RE: Report to Commission and possible Commission action regarding the California Energy Commission’s Application for Certification (12-AFC-02) – AES Southland, LLC Huntington Beach Energy Project, reviewed pursuant to Coastal Act section 30413(d)

RE: Coastal Commission's 30413(d) Report for the Proposed AES Southland, LLC Huntington Beach Energy Project – Application for Certification #12-AFC-02

EXHIBIT No. 5
Huntington Beach Energy Project

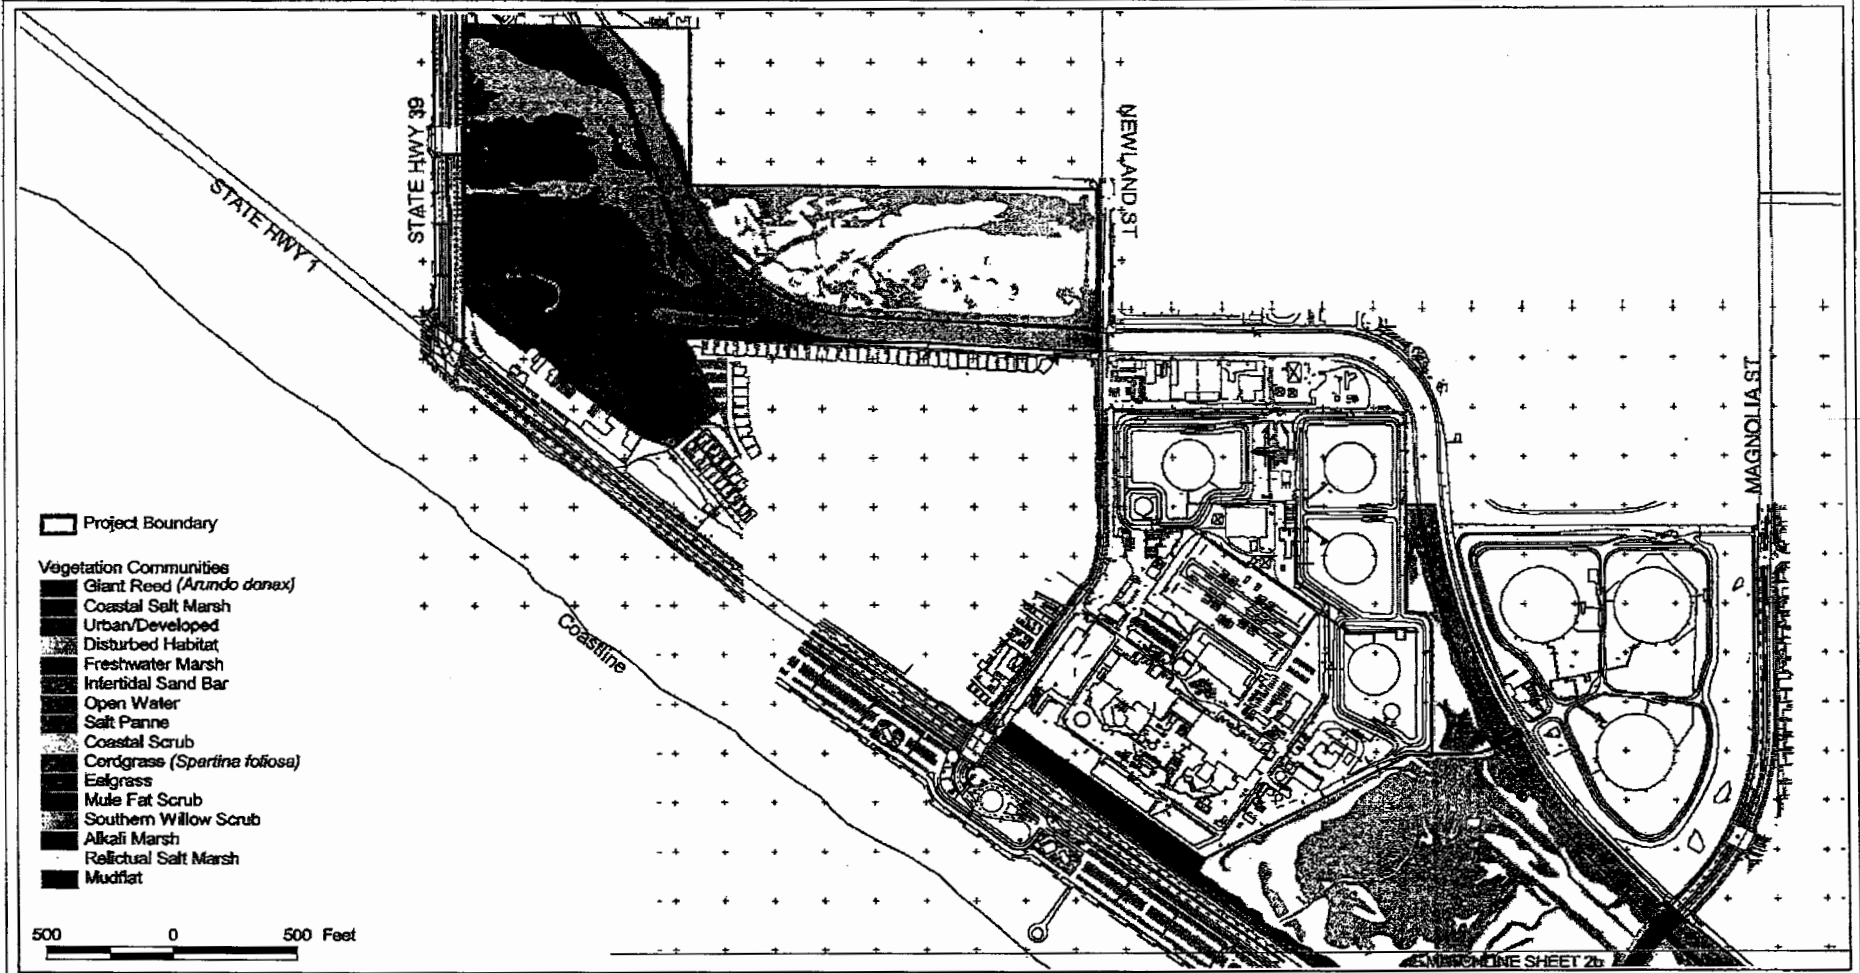
The HBEP site is part of an extensive area of coastal wetlands and dunes that formerly extended for several miles along this area of the coast. The project site is adjacent to the Magnolia Marsh, which provides a mix of wetlands and environmentally sensitive habitat areas (see **Exhibit 5 – Huntington Beach Wetlands Conservancy Site Plan**). Similar habitat extends onto the HBEP site adjacent to the flood control channel.

- To ensure the project conforms to the extent feasible with LCP Policy C7.1.4, we recommend the Energy Commission modify **Condition BIO-7** to require that AES move all project-related development to be at least 100 feet, and further, if feasible, from nearby areas that meet the Coastal Commission's definition of wetlands or ESHA. We also recommend that the project plans required pursuant to **Condition GEN-2** reflect this change in the project layout.

Exhibit IV-D-2: City of Huntington Beach Prado Dam Inundation Map

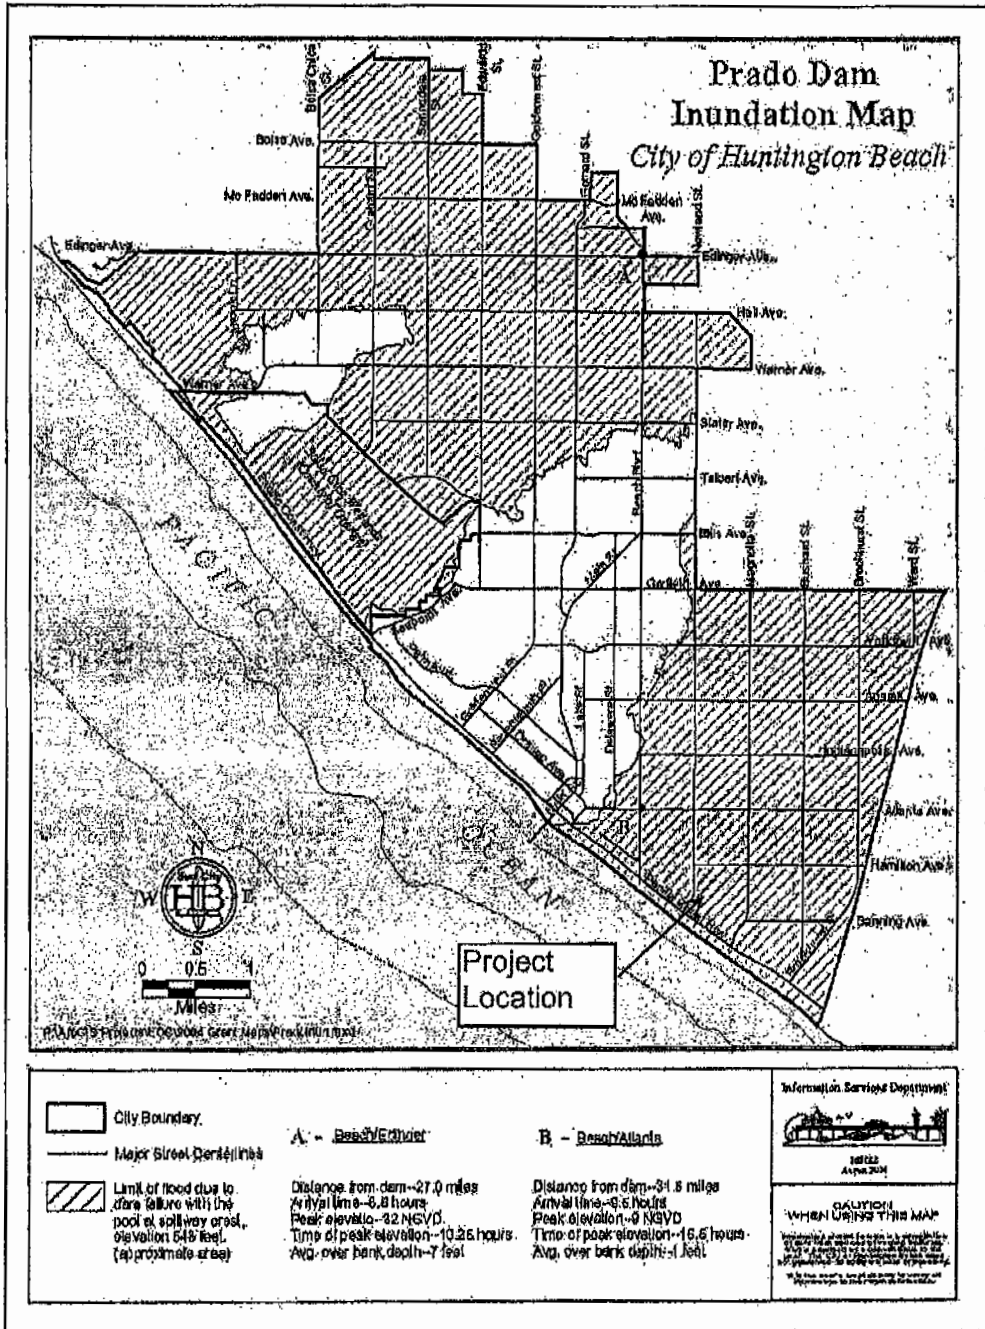
Commission staff used data from the adjacent flood control channel and from a hydrologic analysis of the adjacent Huntington Beach wetlands that show a 100-year flood elevation of between about 9 to 10.2 feet in a nearby portion of the flood channel.²⁴ Data were not available for the 500-year flood event from the City or provided in the FSA, though it is presumably higher. Adding the two feet of projected increase in sea level rise puts the 100-year flood elevation at between 12 and 13 feet, which is in the same range as expected tsunami elevations described below and somewhat lower than inundation from a Prado Dam failure.

Flooding from any of these events could cause significant adverse impacts. For example, below grade facility components could be subject to complete inundation, potentially resulting in plant outages. Additionally, debris carried by a flood could damage above-grade components of the facility, or conversely, structural debris from the facility could damage nearby structures or property. Potential and likely risks include temporary or permanent loss of electricity production to the area, damage to adjacent properties, and increased public costs to provide measures that would protect the facility from these flood events. These flood risks will increase with the expected increase in sea level rise during the project's operating life. The degree of flood protection provided at the site is already influenced by the tides – that is, flood waters are released more slowly during a high tide than during a low tide and back up into the channel and surrounding areas during a high tide – and this effect will increase with sea level rise.

- **Recommended New Condition GEO-3: Flood and Tsunami Hazard Mitigation Planning. Prior to the start of construction, AES shall submit for CPM review and approval, a Facility Hazard Emergency Response Plan developed in coordination with the City of Huntington Beach, Southern California Edison, and the Orange County Flood Control District. The Facility Hazard Emergency Response Plan shall include, at a minimum:**
 1. **Results of hydraulic and hydrodynamic modeling using methods approved by the Federal Emergency Management Agency (FEMA) or the**

MODERATE TSUNAMI RUN-UP AREA
CITY OF HUNTINGTON BEACH GENERAL PLAN

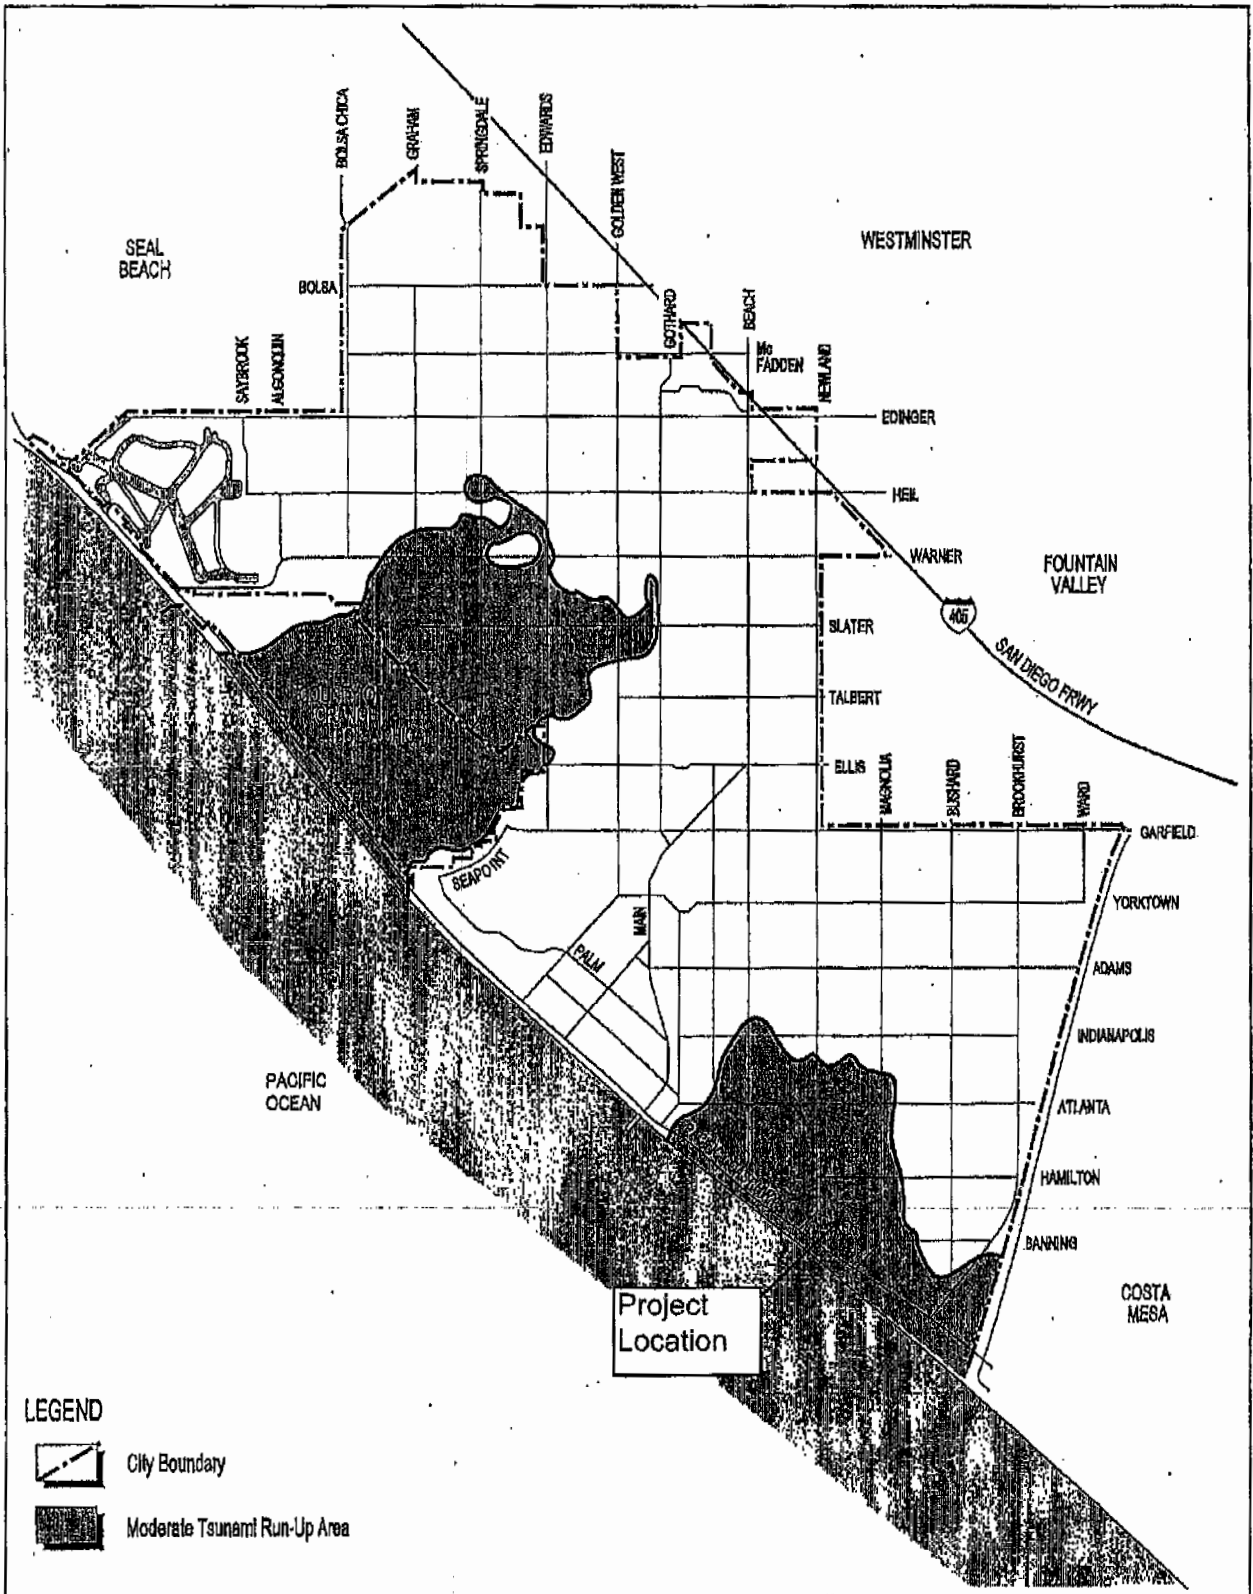
Although the site is located about one-half mile inland from the shoreline, it is subject to significant tsunami hazards. The site sits within a Tsunami Runup Zone the City designated in 1996 that extends about a mile inland from the shoreline (see **Exhibit 10 – Tsunami Runup Zone**).²⁵ At the time of that designation, the City identified expected tsunami elevations of up to five feet for a 100-year event and up to 7.5 feet for a 500-year event. More recent data and updated studies show the site is subject to higher runup levels and more severe tsunami risks. The 2009 California Geological Survey *Tsunami Inundation Map* for the Huntington Beach area shows the site within a tsunami runup zone in this part of the City that extends more than two miles inland, with expected water levels within parts of that zone of up to 16 feet above mean sea

As evidenced by recent tsunami events worldwide and in California, an 11- to 13-foot tsunami can cause significant adverse impacts. At this site, it would result in partial inundation and possible damage to below-grade facility components. It is also likely that damaged structural components could contribute structural debris to the tsunami and worsen the damage at the facility and at nearby structures and properties. Smaller tsunamis can also prove damaging – for example, the Orange County Multi-Hazard Mitigation Plan describes a one- to three-foot tsunami as being highly destructive³⁰ – and at this site, a smaller tsunami could create the same “island” effect as described in the flood hazard discussion above.

GEOLOGY AND PALEONTOLOGY - FIGURE 10
Huntington Beach Energy Project - Fault Map

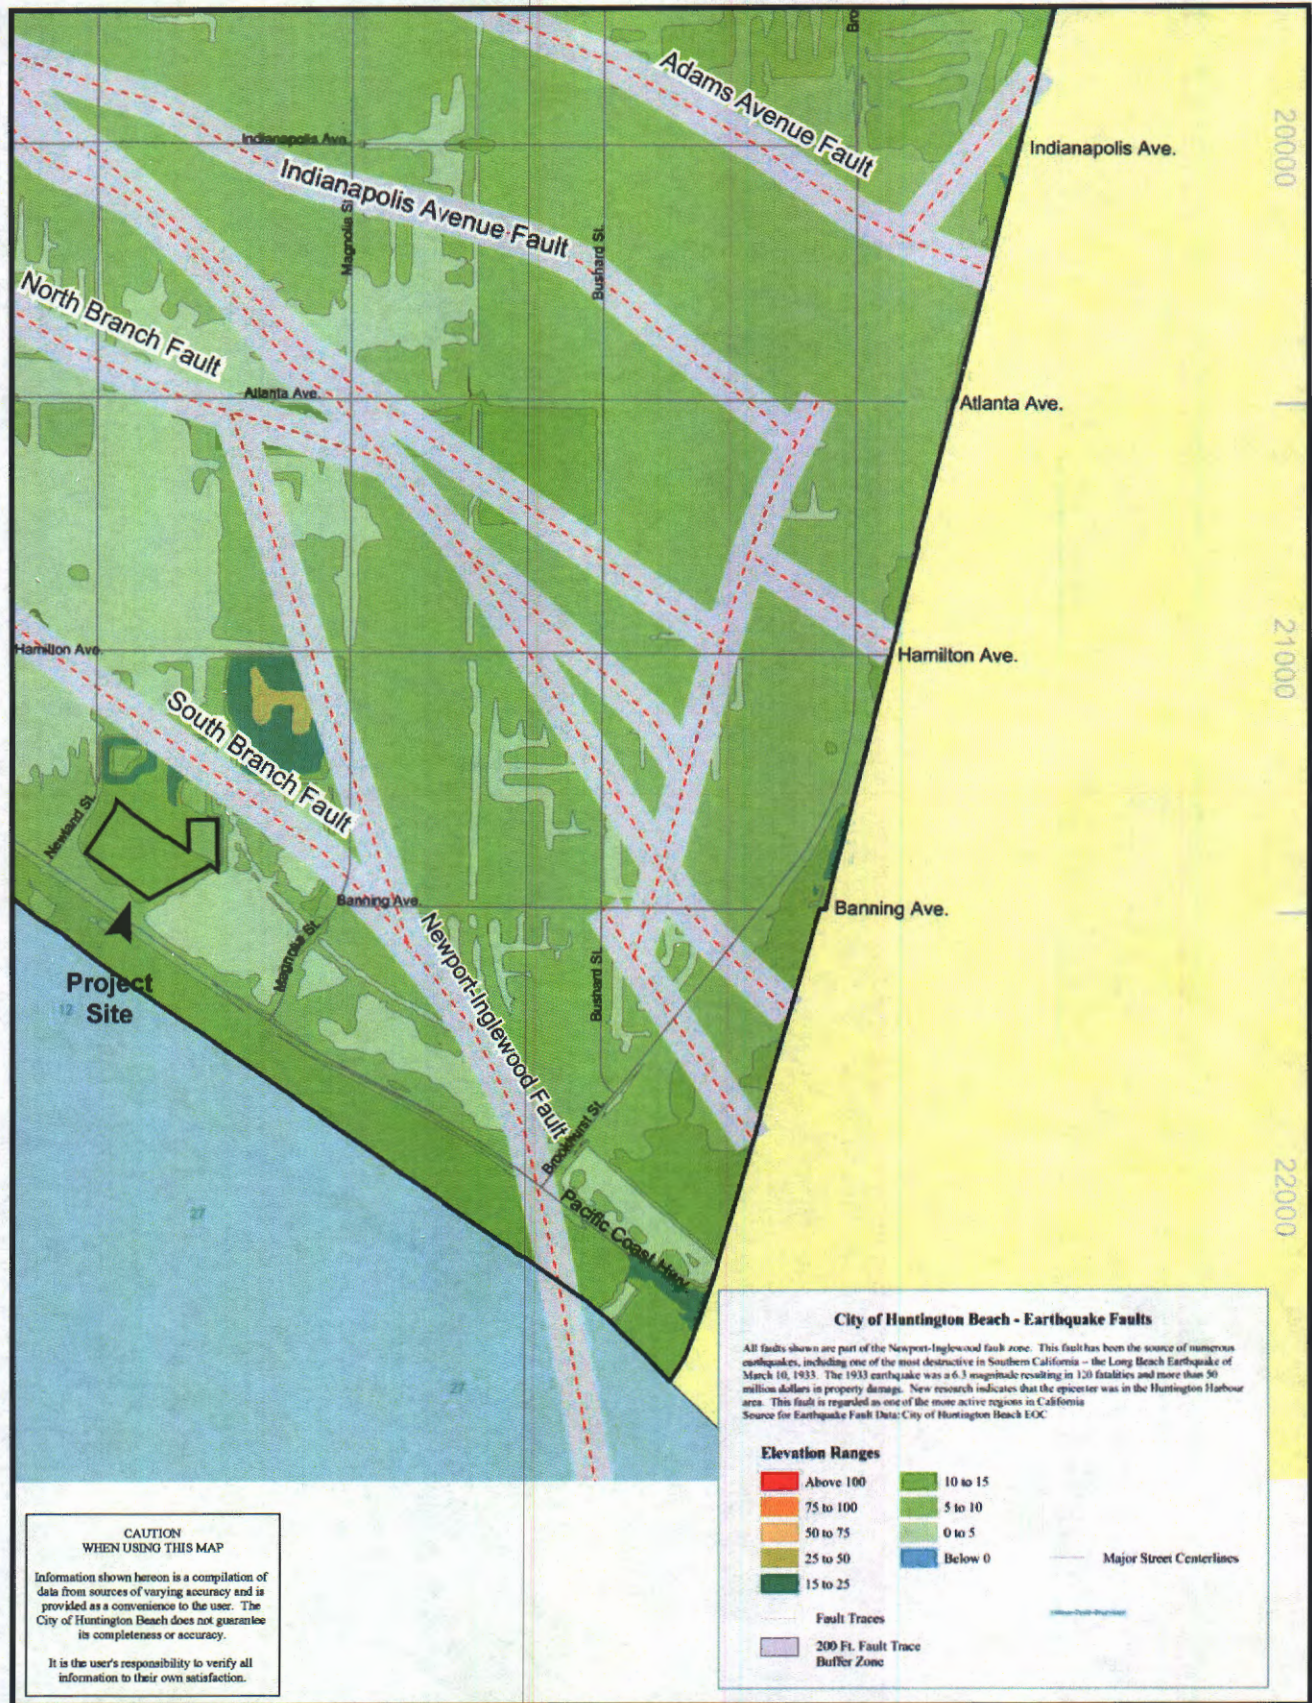
The FSA notes that the proposed HBEP site is likely not subject to surface fault rupture. However, AES’s July 2012 site assessment identified the above-referenced South Branch Fault trace as being located below the northeast corner of the power plant site, and stated it was proposing to locate its new generating units to provide a 500-foot buffer from the mapped fault and the location of potential surface fault rupture.

As noted in the Land Use and Alternatives discussion above, the Commission recommends that Energy Commission staff evaluate whether that part of the power plant site could be used for construction staging or parking that would reduce the project’s effects on offsite coastal resources. That evaluation should include consideration of potential surface fault rupture and geologic stability.
